North Eastern Regional Power Committee

**Sub: 84वीं संरक्षण समन्वय उप-समिति (पीसीसी) बैठक का कार्यवृत्त/ Minutes of 84<sup>th</sup> Protection Coordination Sub-Committee (PCC) Meeting**

### **84<sup>th</sup> Protection Coordination Sub-Committee Meeting**

**Date:** 09/10/2025 (Thursday)

**B.6 Grid Disturbance in Ziro, Daporijo, Basar and Along area of Arunachal Pradesh Power System on 13th Aug'25:**

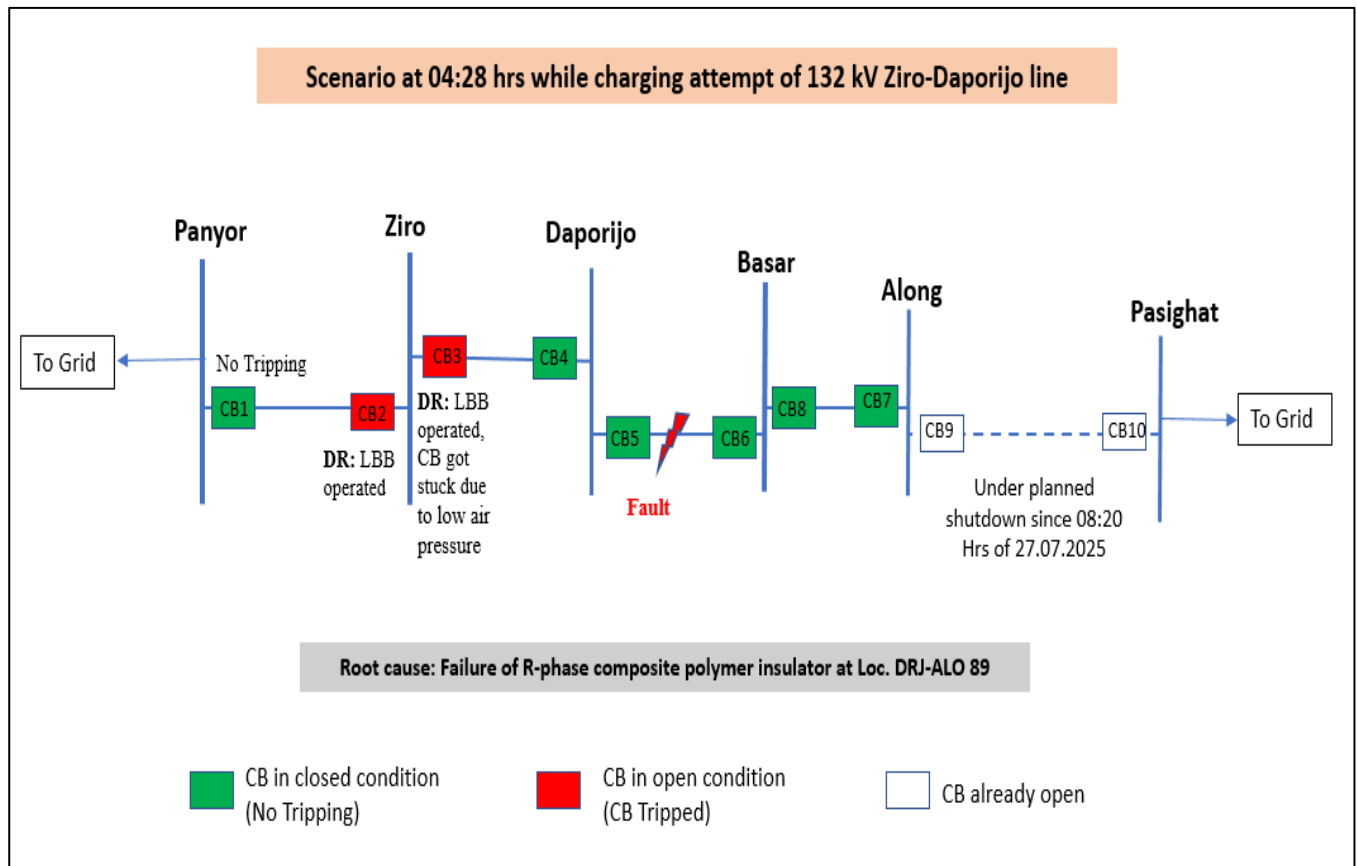
- At 03:31:02.182 hrs, High resistive B-N fault (Ib-189 A, In-146 A, Vb-74 kV) in 132 kV Ziro-Daporijo line cleared on operation of E/F protection from Ziro end. No tripping from Daporjo end (radial)
- While charging attempt of 132 kV Ziro-Daporijo line at 04:24 Hrs, line was charged from Ziro end and at 04:28 hrs during closing of CB at Daporijo end, fault occurred in 132 kV Daporijo-Basar line due to the failure of the R-phase composite polymer insulator at Loc. DRJ-ALO 89.
- Protection system of 132 kV Daporijo-Basar line failed to isolate the fault. CB at Ziro for 132 kV Daporijo line failed to open due to low air pressure, LBB protection operated at Ziro leading to tripping of 132 kV Panyor-Ziro line.

- Share the reason of non-operation of protection system of 132 kV Daporijo-Basar line.

- DR time drift of 2 min observed at Ziro end for 132 kV Daporijo line which needs to be rectified. Availability/healthiness of GPS needs to be ensured and time to be adjusted as per grid code.
- Frequent damage to insulators occurred between Tower Nos. DRJ-ALO 89 and 90 which likely due to area being lightning-prone. Installation of lightning arresters (LA) at this location, along with improvements to the tower earthing, to mitigate future occurrences.

DoP Ar. Pradesh informed that the tripping occurred due to puncturing of insulator by lightning strike. Regarding non-operation of CB#5, he informed that the matter is being looked into.

Regarding non-operation of CB3, PGCIL informed that the CB got stuck. He further informed that the CB was of pneumatic type which has been replaced with spring charging type.

Forum requested DoP Arunachal Pradesh to check the TFR of the towers along the Daporijo-Basar line and ensure maintenance of their protection equipment.

### **B.7 Grid Disturbance in NEIGRIHMS & IIM areas of Meghalaya Power System on 6th Sept'25:**

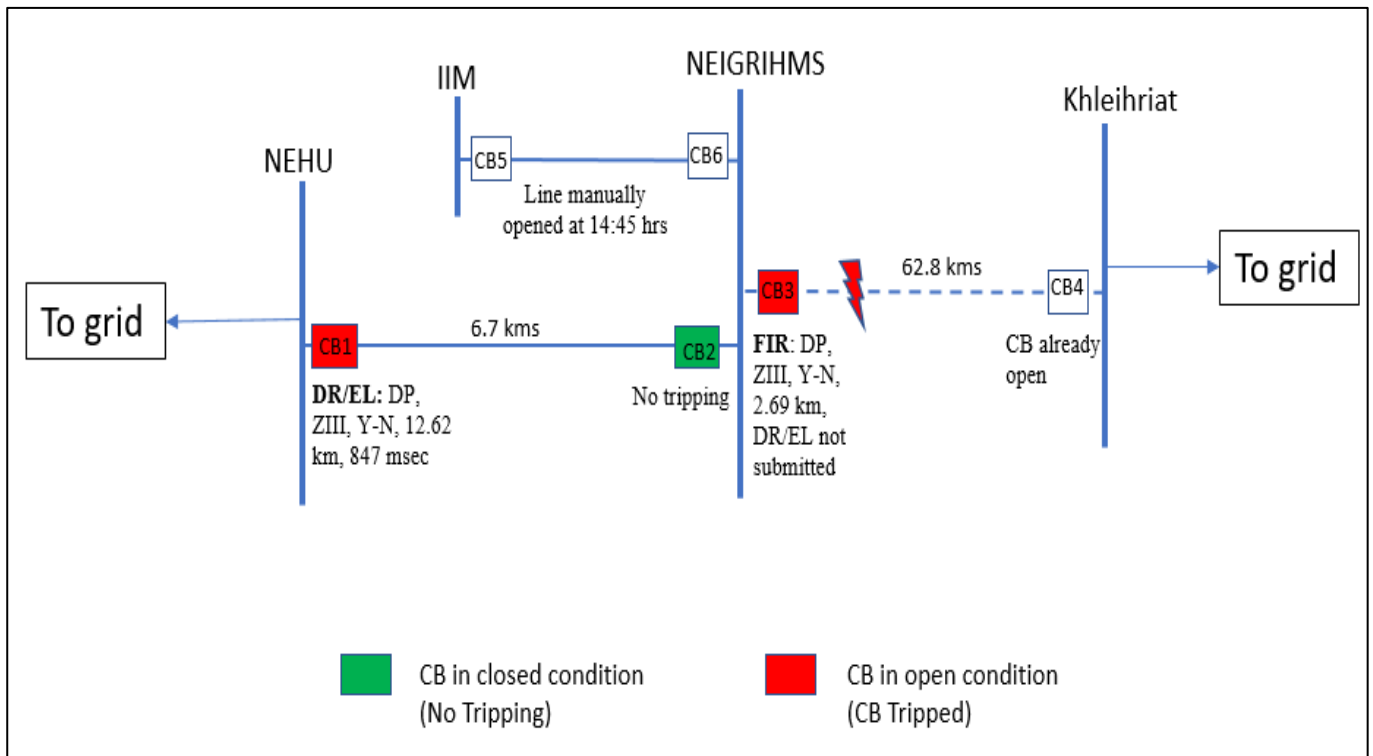
- Review ZII time delay of CB4 and set as per protection philosophy.
- Share the reason why CB3 did not detect the fault in ZI and waited for ZIII time delay despite having fault at a distance of 2.69 km from NEIGRIHMS.
- Tripping of New Umtru Unit-1 seems unwanted. The same needs to be thoroughly investigated.
- Time drift observed: 2 min at Khleihriat end for 132 kV NEIGRIHMS line; 4 min at NEHU for NEIGRIHMS line. Availability/healthiness of GPS needs to be ensured and time to be adjusted as per grid code.

The forum noted that CB3 should have seen the fault in Zone 1 or Zone II given that the CB1 has seen the fault in ZIII.

Meghalaya informed that there are no issues with the relays for CB3 as the fault was highly resistive nature (voltage drop 3-4 kV) at 14:41 hrs. Hence, DPR not able to capture the actual distance. However, the same relay operated correctly at 14:27 hrs (first tripping) due to jumper snapping.

Forum advised Meghalaya to check the distance protection settings for CB3. PGCIL informed that Meghalaya may trans play the fault to check the actual operation of CB3 relay during the fault and take actions accordingly.

**B.8 Grid Disturbance in Rokhia and Mohanpur S/S of Tripura Power system on 18th Sept'25:**

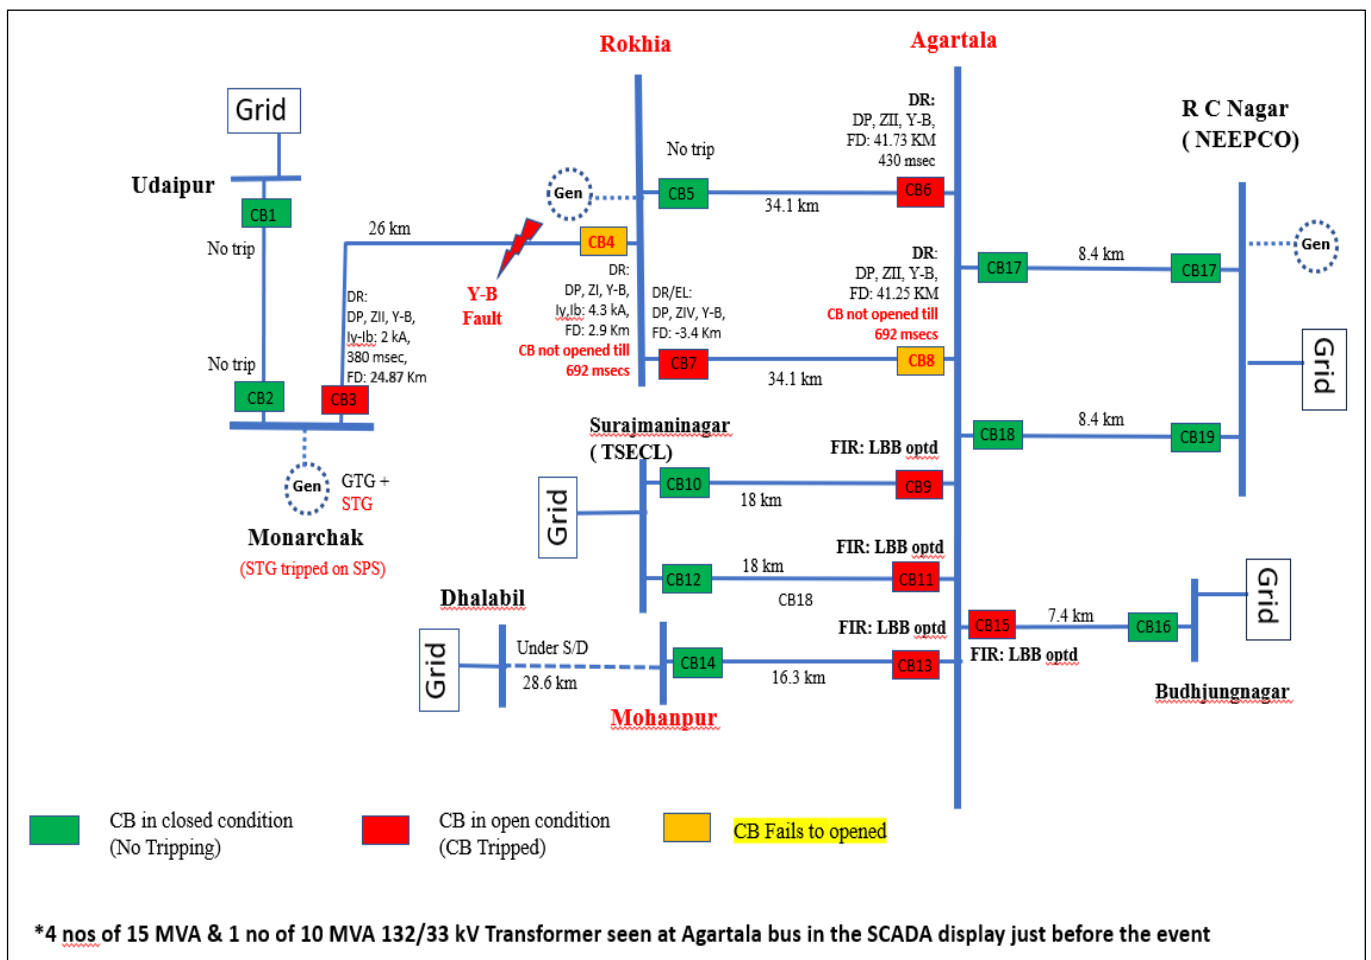
- At 10:35 Hrs, Y-B fault of solid nature appeared in the 132 kV Monarchak – Rokhia line which cleared from Monarchak end correctly. The fault detected at Rokhia end in ZI & issued trip command immediately however the CB fails to opened at Rokhia end resulted into the tripping of 132 kV Rokhia – Agartala 1 after 430 msec.
- 132 kV Rokhia – Agartala 2-line CB fails to open after trip command issued by the DP relay in ZII. The same line tripped from Rokhia end on operation of Z IV (reverse) in 692 msec from the initiation of the fault resulted into the GD at Rokhia SS.
- LBB operated at Agartala bus during CB stuck of Rokhia II line caused tripping of 4 lines, however, 132 kV AGTCCPP – Agartala 1 & 2 line not tripped. LBB operation at Agartala SS caused the GD at radially fed Mohanpur area of Tripura.

- Share the reason of non-opening of CB at **Rokhia** for 132 kV Rokhia - Monarchak Line.
- Share the reason of non-opening of CB at **Agartala** for 132 kV Agartala – Rokhia 2 Line.
- LBB healthiness as well as connectivity to all the element connected at Agartala need to be ensured. Actual LBB initiation & operation time not concluded.
- Disturbance Recorder (DR) lack proper recording of CB OPEN & CLOSE status as well as LBB operation in each of the connected element at Agartala and Rokhia which needs to be ensured.
- Status of CB & ISO at Agartala could be collected from the SCADA system during the event. The remedial action should be taken for proper monitoring & event analysis.

Regarding non-operation of CB4, Tripura informed that control cable had got burnt which is yet to be replaced. Forum instructed TPTL to carry out the tests like CRM and DCRM tests for the CB within one week and ensure that there are no joints in the control cable.

Regarding non-operation of CB8, TPTL informed that master trip relay contact had got burnt and will change the relay shortly.

Forum also noted that LBB operation has not taken place correctly at Agartala and instructed TPTL to provide LBB healthiness report to NERPC and NERLDC.

**B.10 Grid Disturbance in Kolasib, Tuirial & Bairabi HEP of Mizoram Power System on 15th Sept'25:**

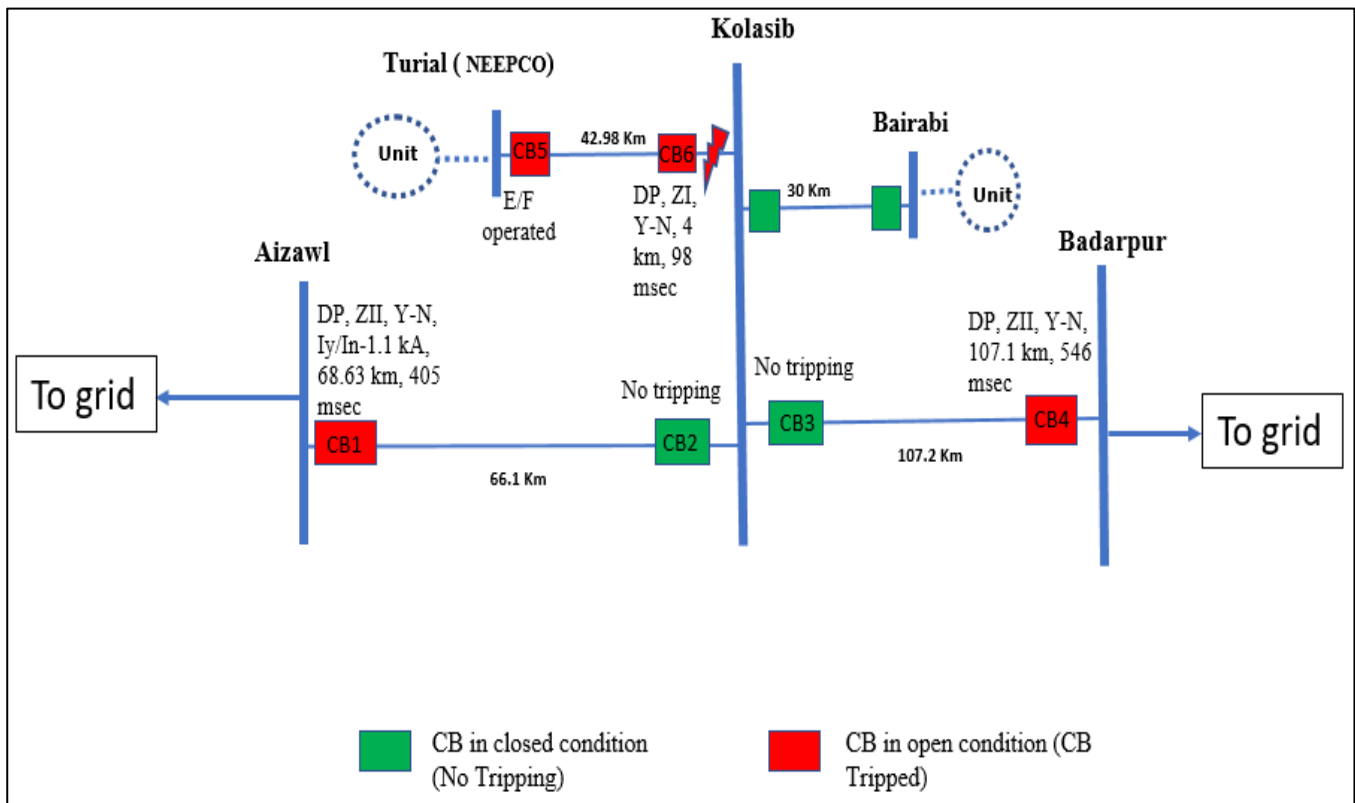
- Likely High set E/F enabled at Turial end of 132 kV Kolasib line which need to be disabled.
- E/F setting needs to be reviewed at Turial & Kolasib end along with its directionality.
- P&ED Mizoram to review relay setting of all elements at Kolasib S/S.

- As informed by P&ED Mizoram, in 132 kV Kolasib-Tuirial line, Line CVT not present at Kolasib end which needs to be looked into by P&ED Mizoram.
- Non-submission of Detailed analysis report of the event by P&ED Mizoram which is a violation of Clause 37.2 (e) of IEGC regulation 2023.

Mizoram informed that fault occurred in the Tuirial-Kolasib line and line CVT is available on the Tuirial-Kolasib line. However, NERLDC raised the availability as Kolasib end using Bus PT for protection 132 kV Kolasib – Tuirial line as observed during the DR as well as SLD shared after the incident. Hence, Mizoram to cross check once again.

Likely High set E/F enabled at Tuirial end of 132 kV Kolasib line which need to be disabled at Tuirial. E/F setting needs to be reviewed at Tuirial & Kolasib end along with its directionality.

### C.1 Grid Event at Sanis 30th Aug'25 and 3rd Sep'25:

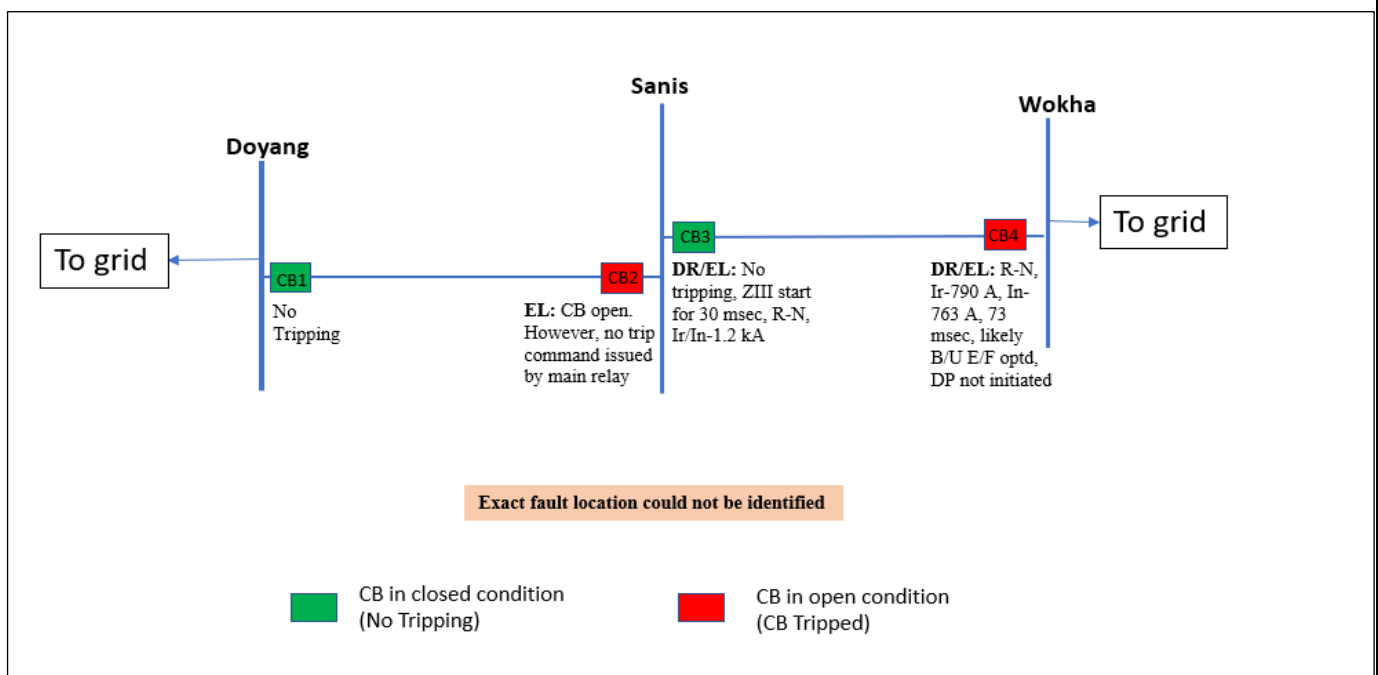
From Sanis end (main relay), ZIII initiated for R-N fault (Ir-1280 A, In-1250 A) fault current disappeared within 30 msec likely after the CB opening at Sanis end of 132 kV Doyang- Sanis line. However, CB was closed as per submitted DR.

Exact fault location could not be identified. However, the suspected fault seems beyond the Wokha substation as indicated by the ZIII initiation at Sanis end for 132 kV Sanis – Wokha Line.

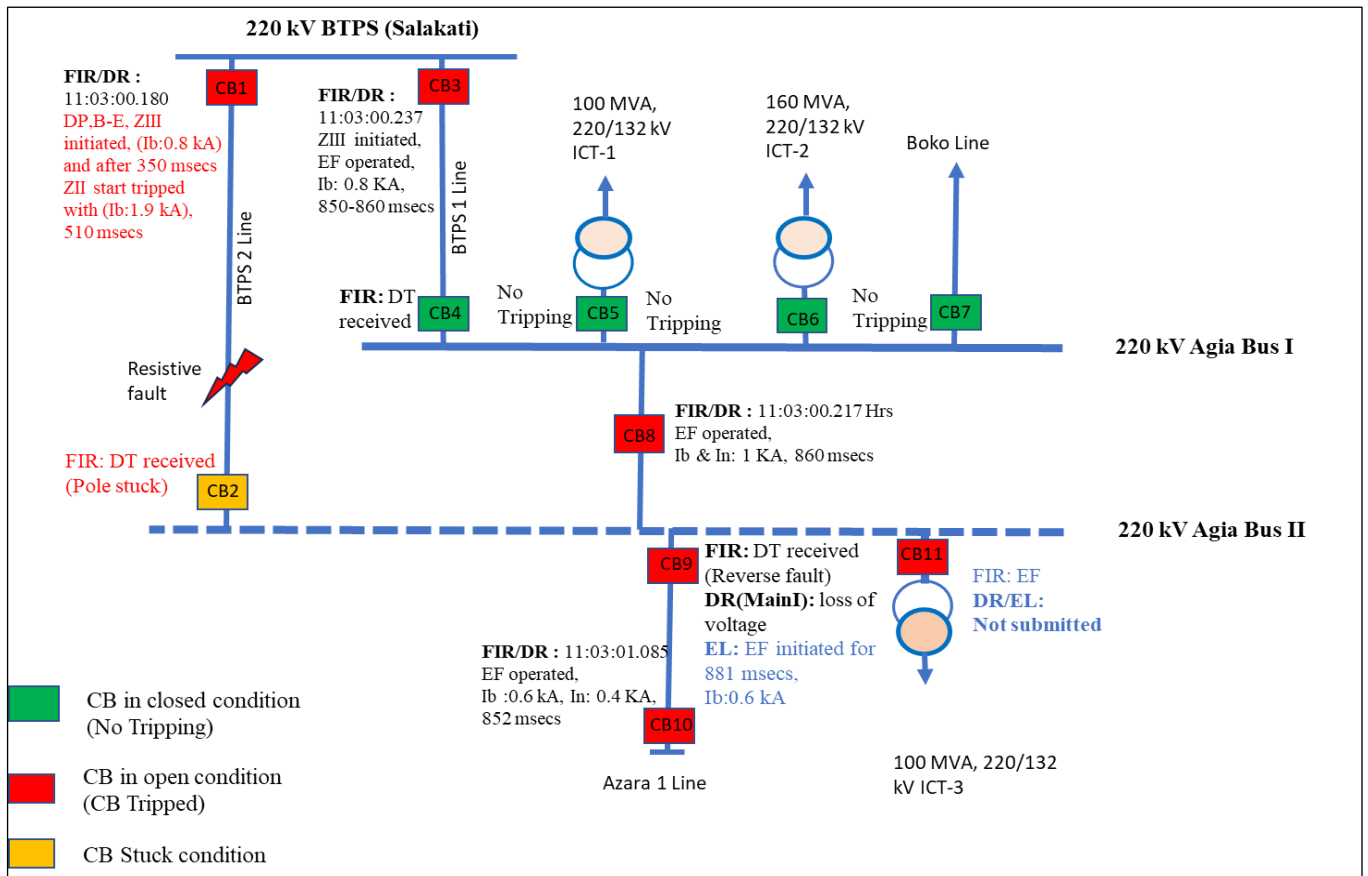
High resistive fault observed in the 220 kV Agia – BTPS II line, cleared from BTPS end by the DP, ZII protection within 510 msecs. Also send DT signal to Agia end. However, the CB got stuck at Agia for the same line.

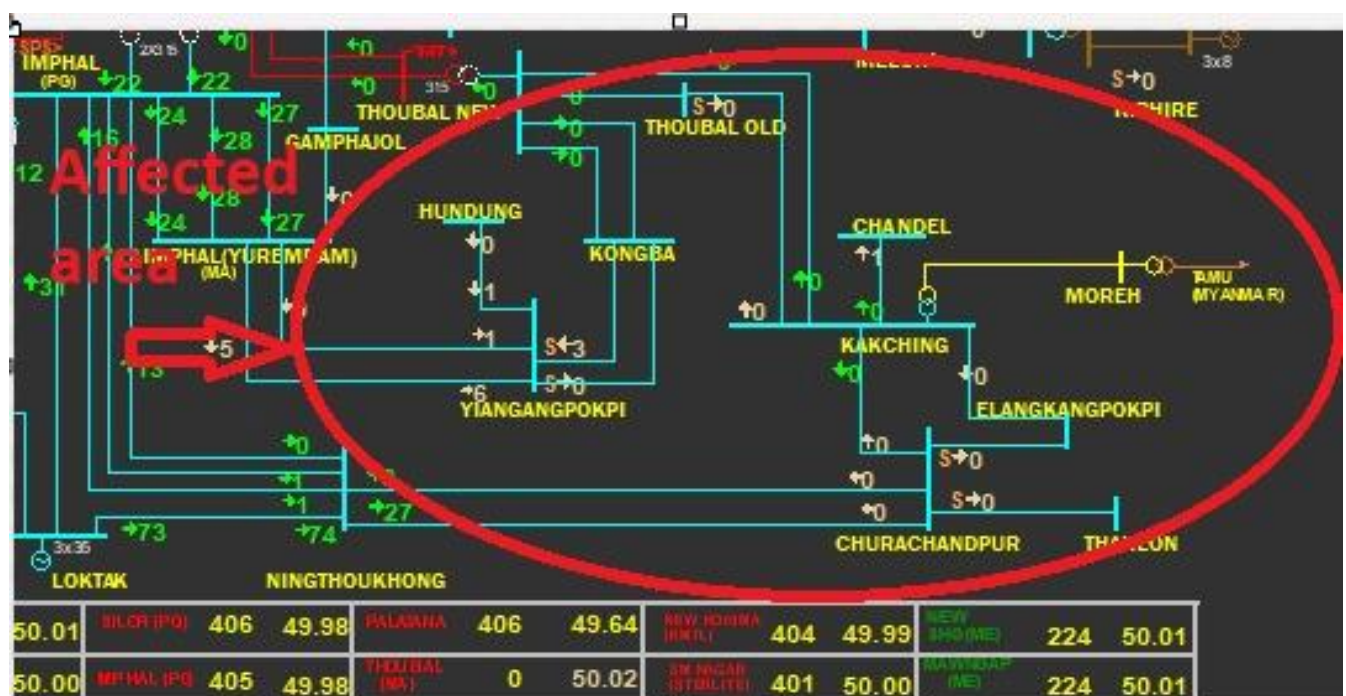
Multiple areas of Manipur were feeding through Imphal & Ningthoukhong substation with 132 kV Ningthoukhong-Churachandpur 2 line and 132 kV Imphal-Yiangangpokpi I line only.

- I. Requirement of the testing of the static relay at Ningthoukhong to check the healthiness (as per setting relay should not have operated due such loading). Also, static relays to be replaced with numerical type as early as possible.
- II. Backup setting need to be incorporated in the main to cross verify the performance of the backup OC, EF relay (static relay) at Ningthoukhong.
- III. Overloading setting need to be revised for 132 kV Imphal – Yiangangpokpi 1 line (currently pickup current: 300 A only).
- IV. Time drift of 1 hr observed in the DR of Yurembam (Imphal). The same need to be matched.
- V. Time synchronizer need to installed at Imphal & Ningthoukhong as early as possible.

1. Revised the O/C pickup current setting at Yurembam for the Yiangangpokpi line to 450 Amps.
2. Replace all the static and electromagnetic relays with the numeric relay in their system
3. Put the B/U protection settings in the Main relay at Ningthoukhong for the Churachandpur line.
4. Perform testing of the static relay at Ningthoukhong to check the healthiness (as per setting relay should not have operated due such loading).
5. Time synchronizer need to installed at Imphal & Ningthoukhong as early as possible.

1. OC pickup current setting has been modified at Yurembam
2. Regarding replacement of static and EM relays with the numerical one, proposal has been put up to higher authorities

3. BU protection settings have been fed in the main relay at Ningthongkong for Churachnampur line

#### C.4 Grid Disturbance in Mynkre area and Leshka HEP of Meghalaya Power System on 1<sup>st</sup> June'25:

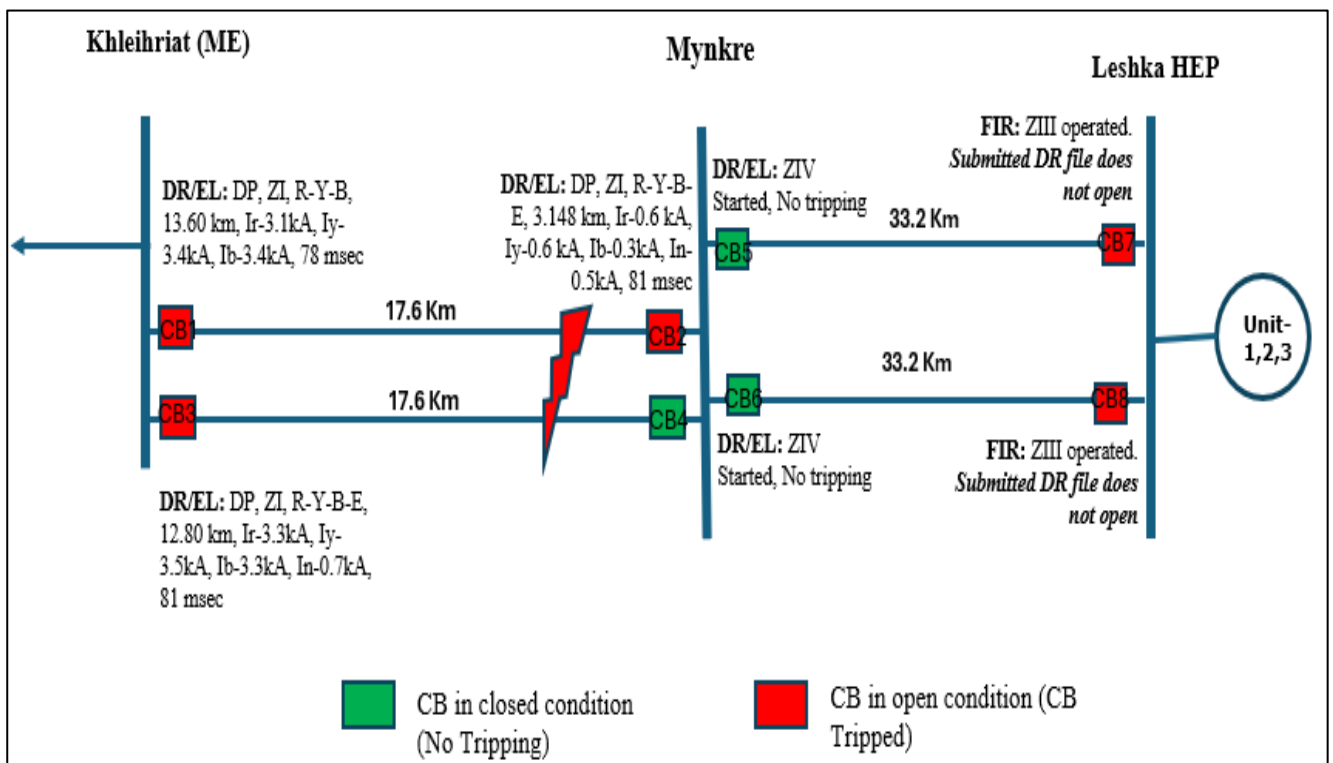
As per DR analysis of 132 kV Mynkre (ME)-Khliehriat(ME) 1 line, solid R-Y-B fault (Ir-3.1 kA, Iy-3.4 kA, Ib-3.4 kA) initiated at 05:37:08.630 Hrs which was cleared within 81 msec on operation of DP, ZI.
